**DEPARTMENT OF TRANSPORTATION**  
 DIVISION OF ENGINEERING SERVICES  
 Office of Structural Materials  
 Quality Assurance and Source Inspection

## QUALITY ASSURANCE -- NON-CONFORMANCE REPORT

**Report No:** NCR-000357

**Reference Description:** Improper Welding Practices on SP207

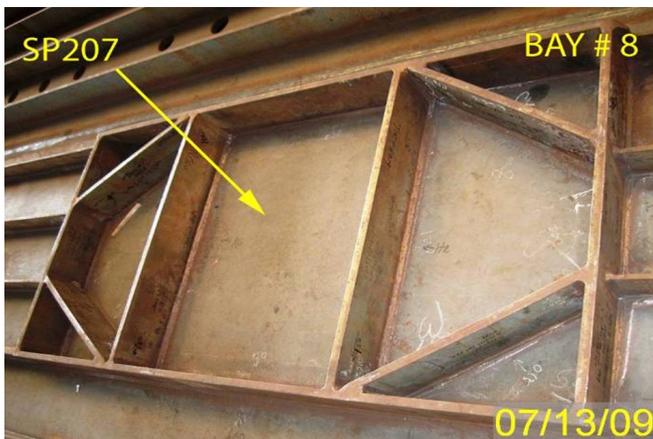
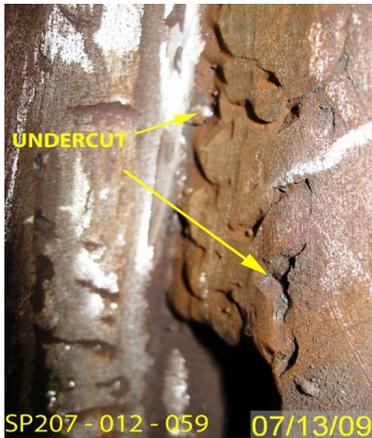
1. Plates X209F do not have 10mm snipe at interface areas with plates X209E as per detail Sheet No. SP207.
2. 8mm fillet weld was not completed full length of plate X209E as detailed.
3. Arc strikes are located on plate X209E.
4. Undercut on weld SP207-012-059 measured 3mm in depth.

Recommendation: 建议:  
 Educate welder and Balance inspection on-site.  
 对焊工进行教育, 并对 Q.C 的抽查力度进行加强

Reference Description: Improper Welding Practices on SP207

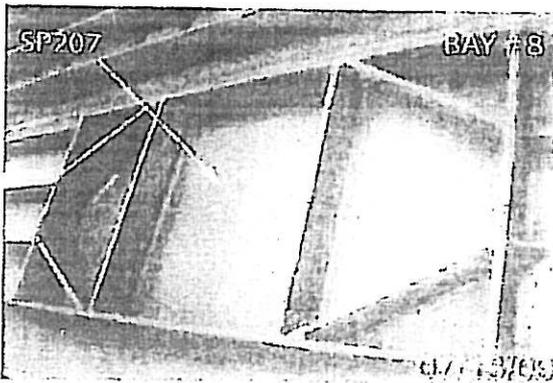
1. Plates X209F do not have 10mm snipe at interface areas with plates X209E as per detail Sheet No. SP207.
2. 8mm fillet weld was not completed full length of plate X209E as detailed.
3. Arc strikes are located on plate X209E.
4. Undercut on weld SP207-012-059 measured 3mm in depth.

Reference Description: Improper Welding Practices on SP207

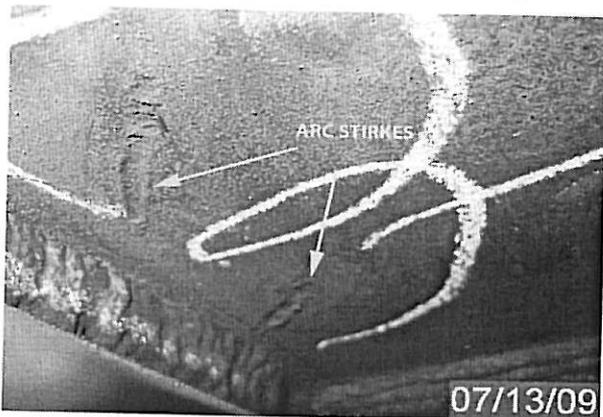
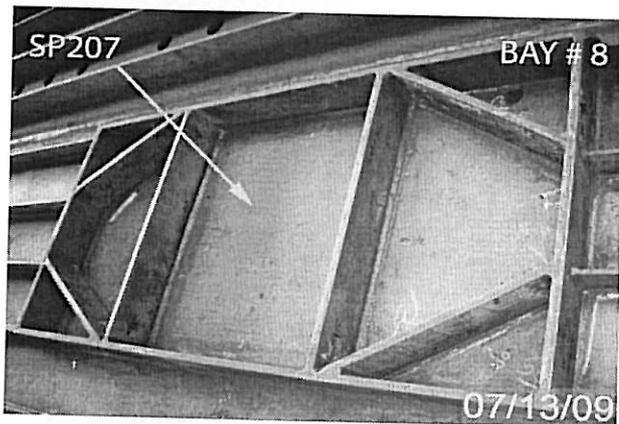
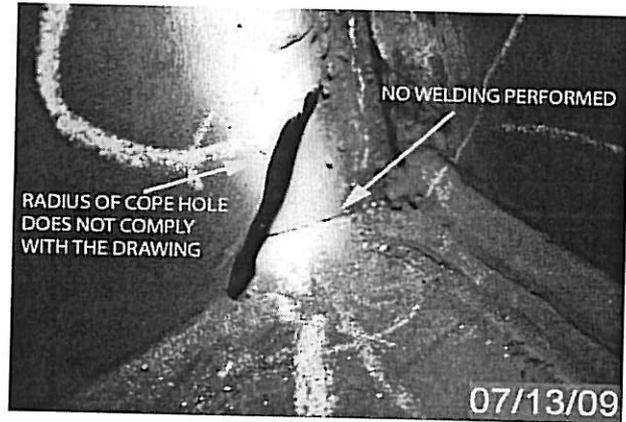
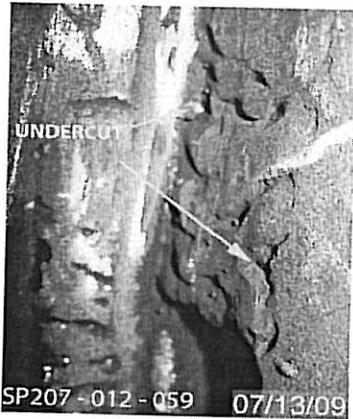
1. Plates X209F do not have 10mm snipe at interface areas with plates X209E as per detail Sheet No. SP207.
2. 8mm fillet weld was not completed full length of plate X209E as detailed.
3. Arc strikes are located on plate X209E.
4. Undercut on weld SP207-012-059 measured 3mm in depth.

Snipes were added to X209F Plates in accordance with approved Shop Drawings, the fillet weld on Plate X209E was completed, the noted arc strikes were repaired, and the undercut issue on weld SP207-012-059 was corrected. The Contractor submitted VT reports for the members/welds listed along with the signed Green Tag verifying SP207 is in conformance with Contract requirements.
